This letter is to formally notify you that the following modification that was completed by Compatible Electronics, Inc. to our Comfort Air Model 275-XXX during FCC certification will be implemented in production.

Modification:

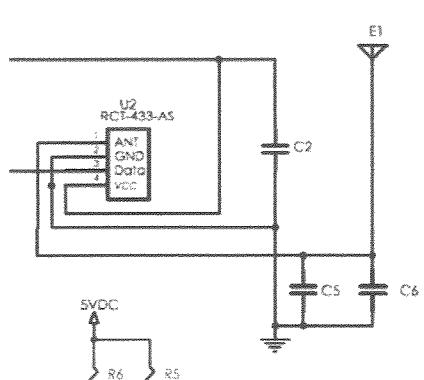
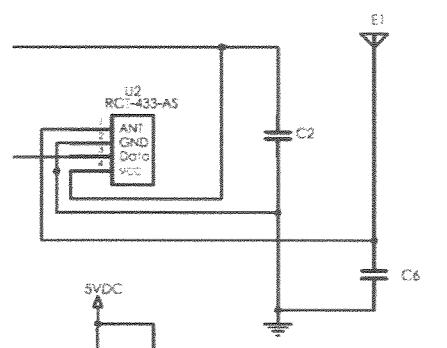
A 6pF capacitor (reference C5) has been removed from circuit. A 6pF capacitor (reference C6) remains between output of transmitter and ground.
